Technical Service Bulletin

EG-0096L-1112

Subject:
DTC P0731/P0732/P0867/P0990 - Hybrid warning lamp comes ON

Models:
 GS450H; LS600h
 Model codes:
 GWS191; UVF45; UVF46

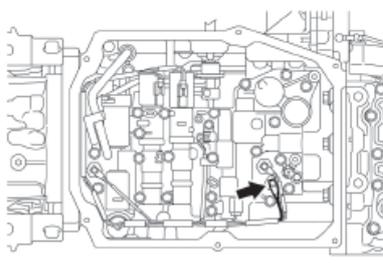
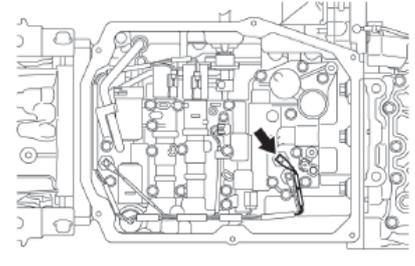
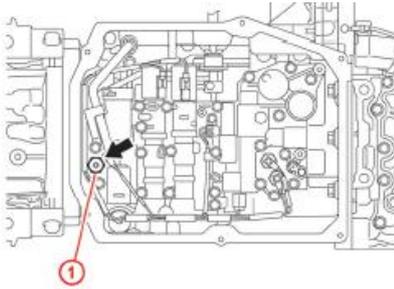
- Remove the oil pressure switches from the valve body

1: Oil Pressure Switch PB1

1: Oil Pressure Switch PB2

1: Oil Pressure Switch PB3

Install the NEW oil pressure switches.

- Install the NEW oil pressure switches to the valve body.

Torque: 4.4 N*m (45 kgf*cm, 39 in*lbf)

Oil pressure switches PB1 and PB2 (part number 83531-30011) are marked with blue paint.

The oil pressure switch PB3 (part number 83531-3002#) is marked with purple paint.
